WISHTOYO
CHUMASH FOUNDATION

THE JOHN MUIR PROJECT
OF EARTH ISLAND INSTITUTE

August 14, 2020

Re: Reyes Peak Forest Health and Fuels Reduction Project

Figure 4

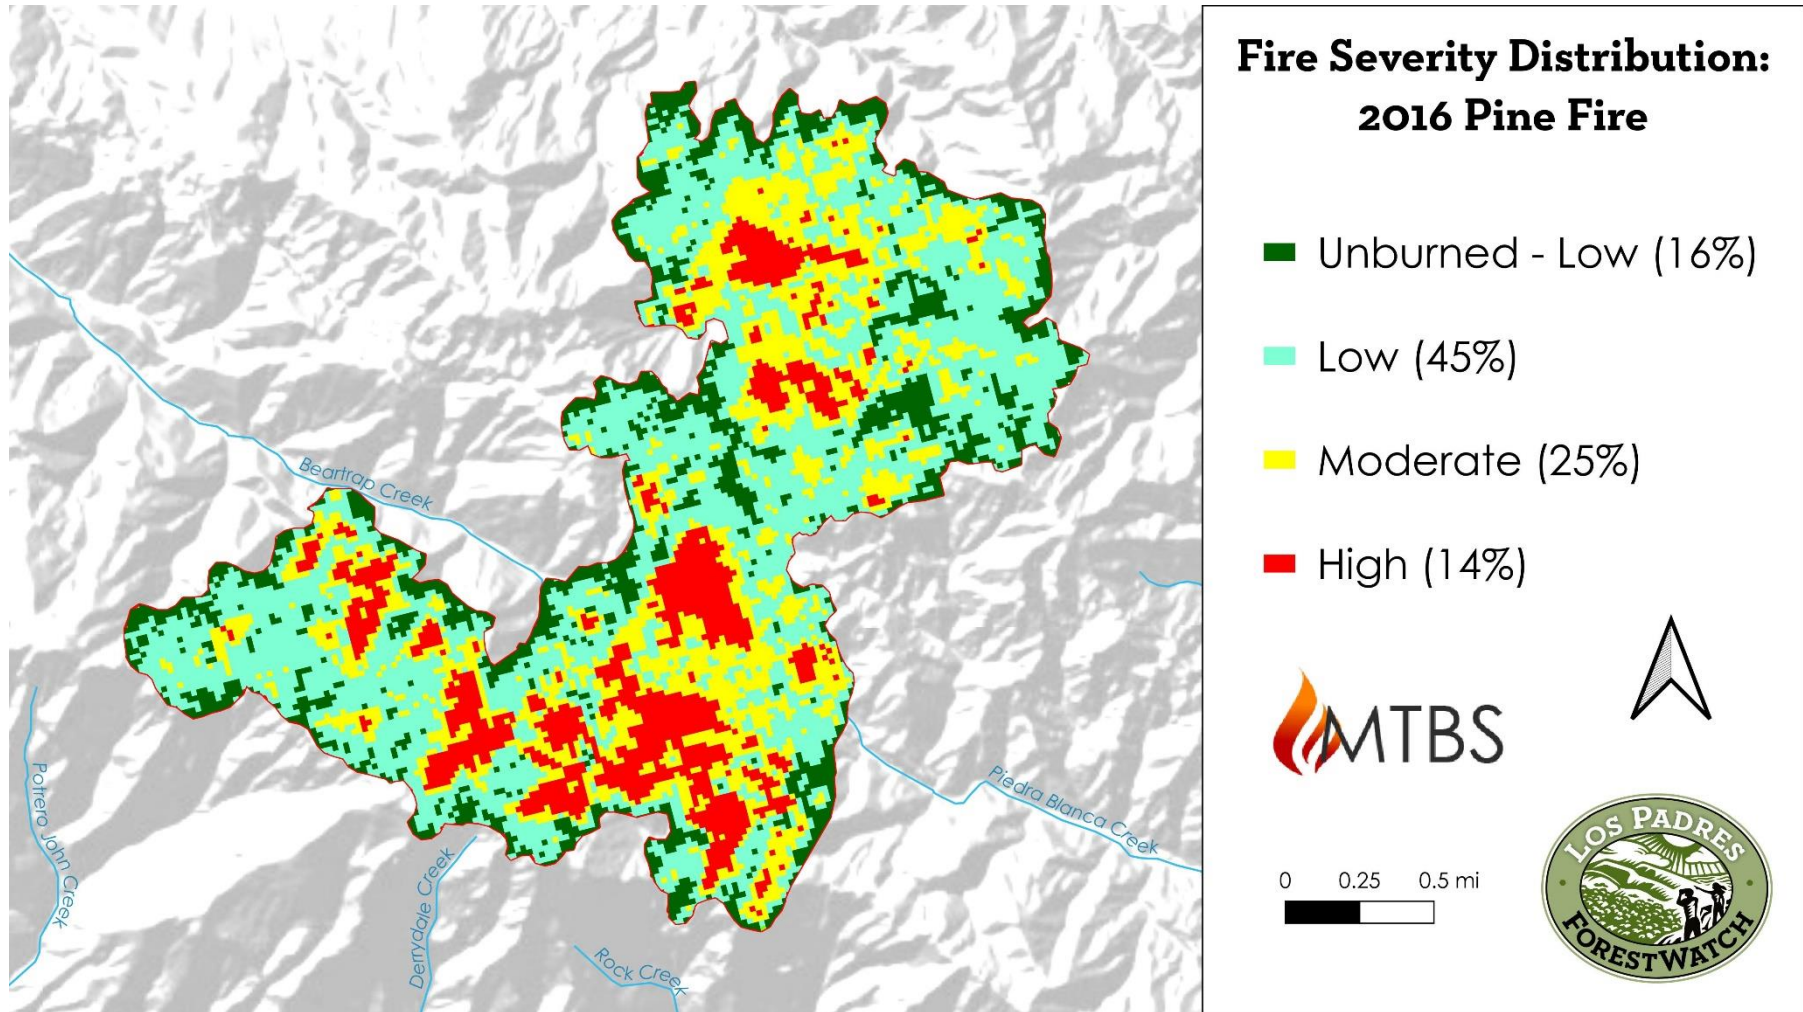
Despite the amount of time since the previous fire, most of the Pine Fire area burned at low- to moderate-severity. According to the Monitoring Trends in Burn Severity database⁵⁹ prepared in part by the Forest Service, the Pine Fire was characterized as predominantly unburned, low-, or moderate- severity fire (2,008 acres or 86% of the total area) and as high-severity to a much smaller extent (336 acres or 14%) as shown in Figure 4.

Figure 6

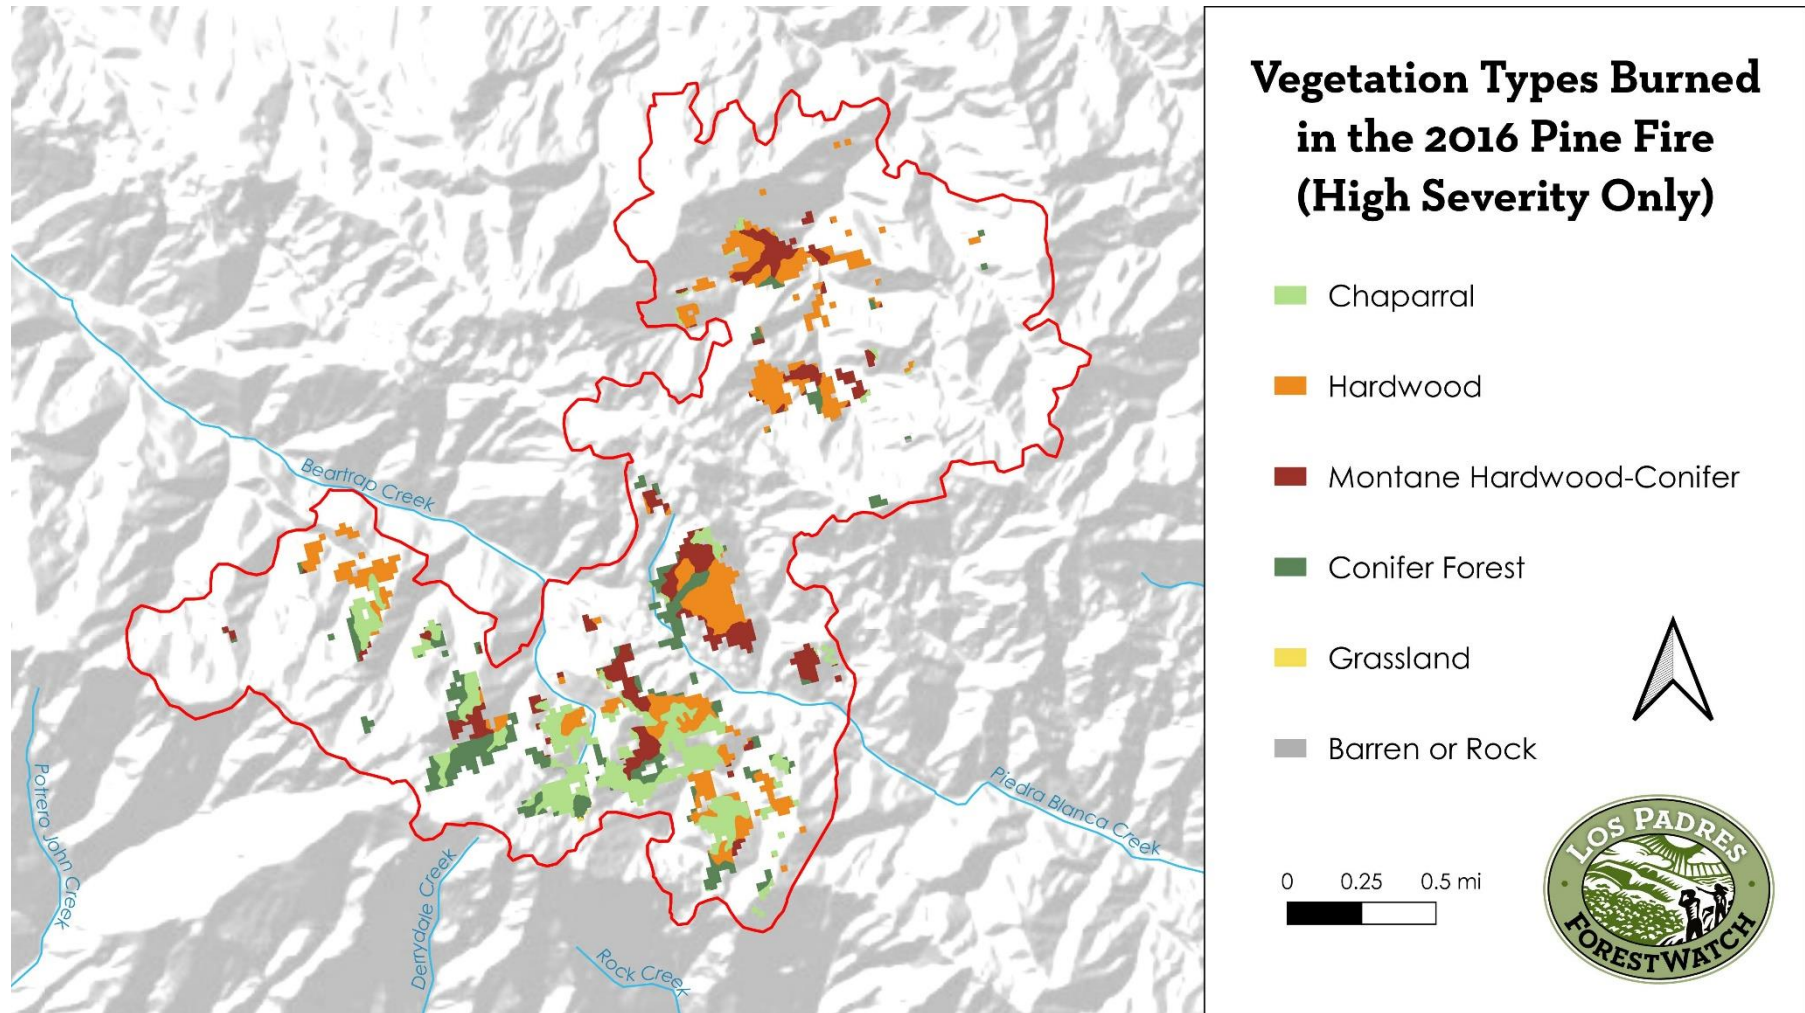
acres that burned at high severity during the 2016 Pine Fire were characterized primarily as montane hardwood (115 acres or 34%) which is generally comprised of canyon live oak (*Quercus chrysolepis*) and montane chaparral (91 acres or 27%). The remaining 130 acres included mostly montane hardwood-conifer and, to a very small extent, other coniferous forest types such as Sierran mixed-conifer. The vegetation types found throughout the burned area can be seen in Figure 5 while the vegetation types found in just those areas that burned at high severity can be seen in Figure 6. Thus, conifer forest types were relatively unaffected by high severity fire.

Figure 11

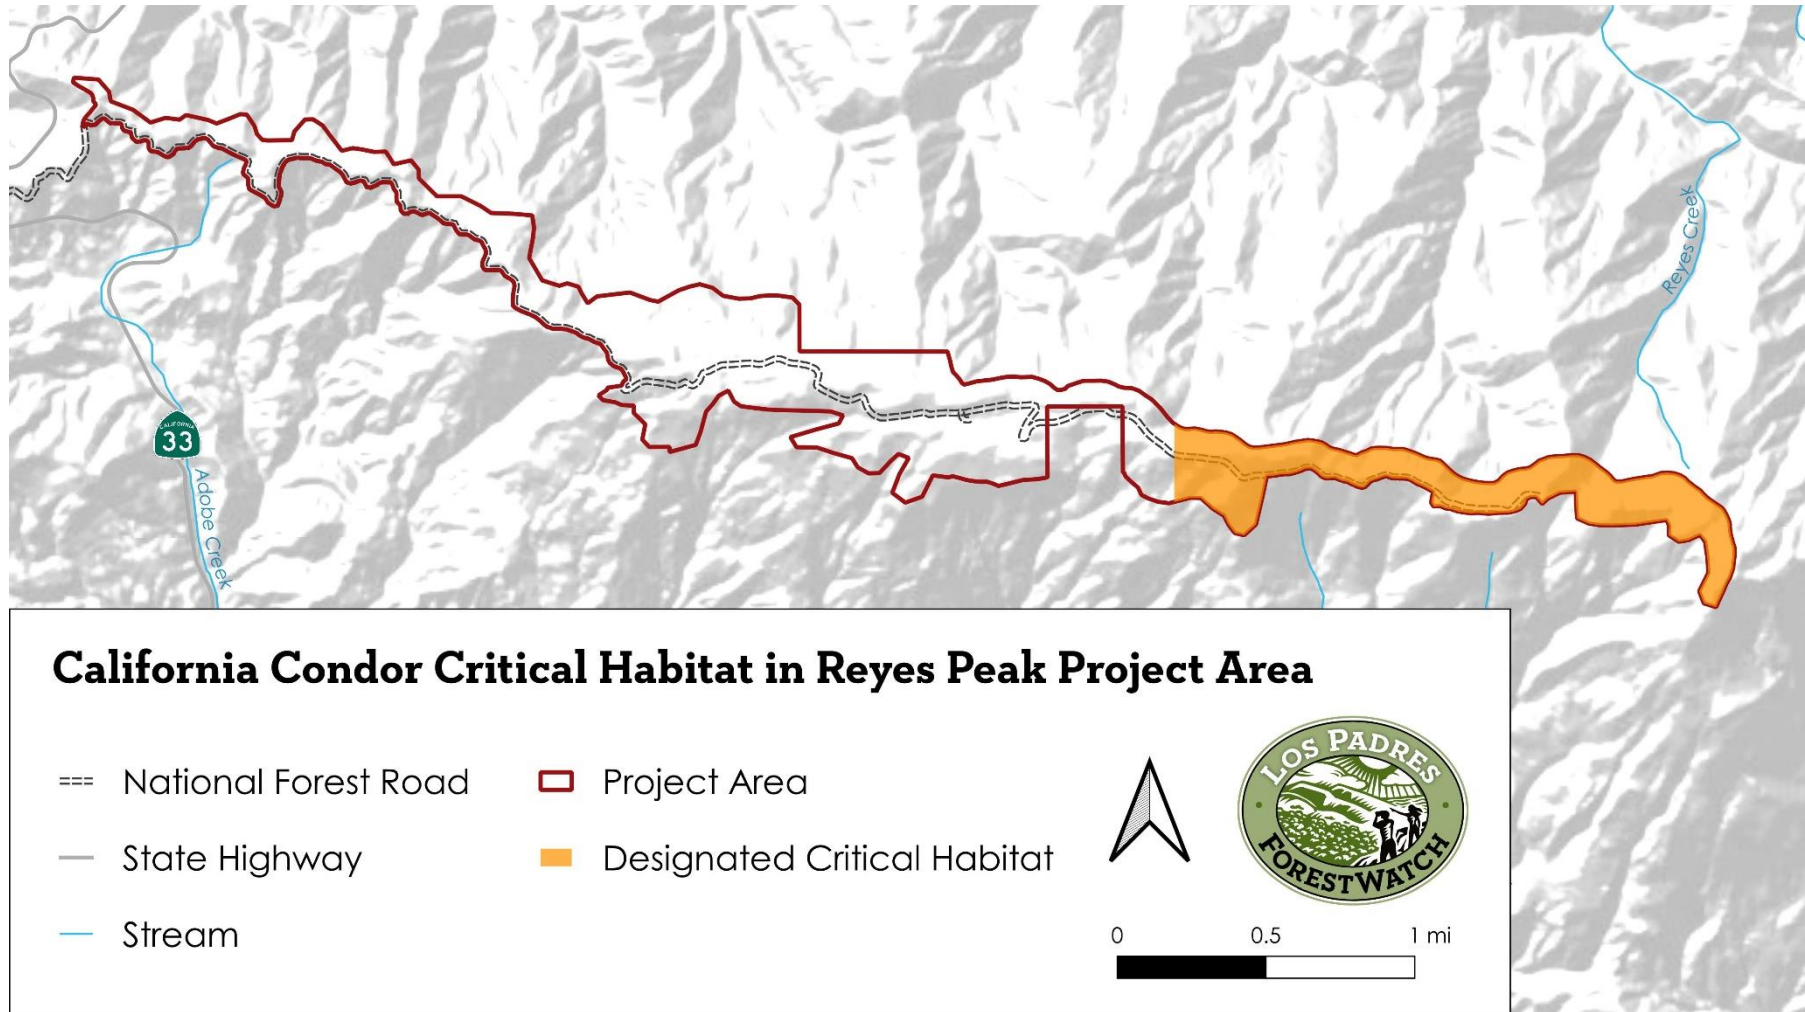
Approximately 192 acres of the Project Area is designated critical habitat for the endangered California condor (*Gymnogyps californianus*) as shown in Figure 11. While the Project Description includes S28 from the LMP (which focuses on avoidance of disturbance to active nests and roost sites), it does not adequately address whether the Proposed Action would cause an adverse modification of the species' critical habitat.

Given that much of the Project Area is designated critical habitat, the possibility of adverse modification to this habitat is significant. The agency therefore must prepare an EA or EIS to better determine what the Proposed Action's impacts to California condor critical habitat may be and how they will be mitigated.

Figure 15

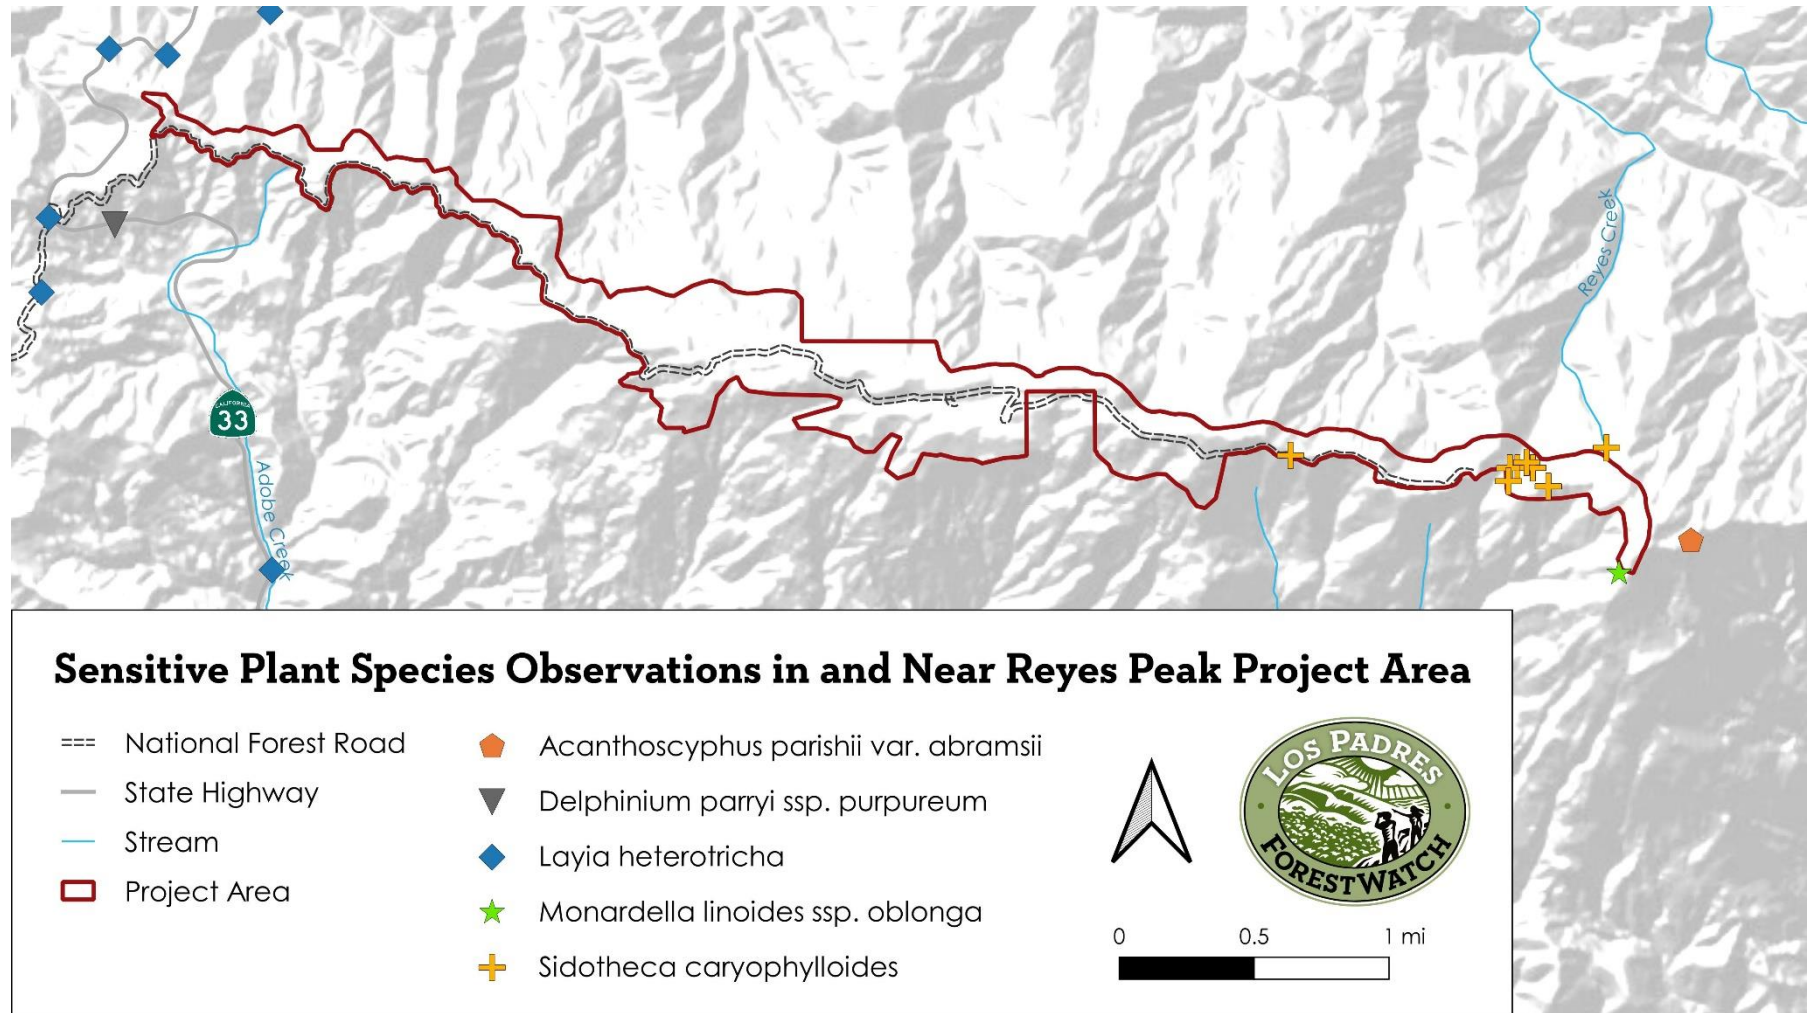
Observation locations for these species near the Project Area are shown in Figure 15. According to the agency’s species account¹³⁰ for Abrams’ spineflower—a small species that occurs in chaparral—states:

Not only is this species threatened specifically by the type of activities included in the Proposed Action, it also has a large population within the Project Area (Figure 15). Impacts to this species during implementation of the Project are highly likely.

Figure 16

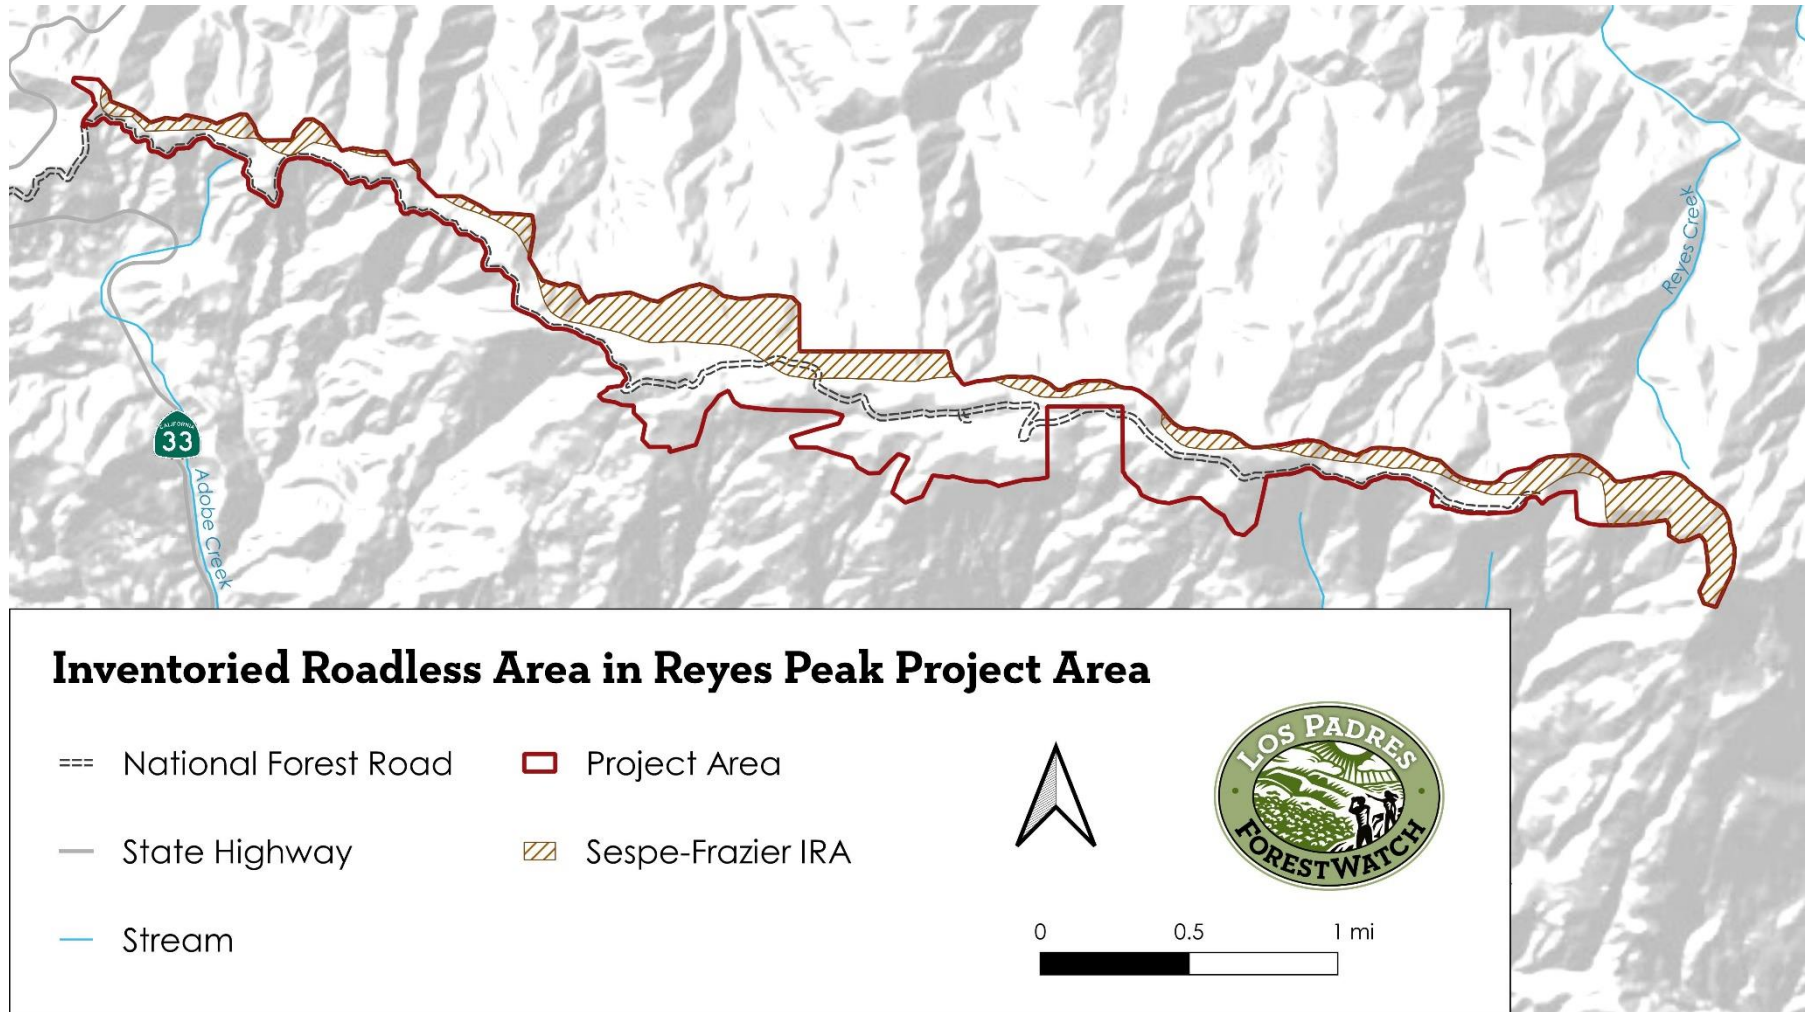
According to the Project Description, 311 acres within the Project Area (42%) are part of the Sespe-Frazier IRA (Figure 16). This includes much of the eastern portion of the Project Area near Reyes Peak as well as areas along the northern edge of the Project Area.
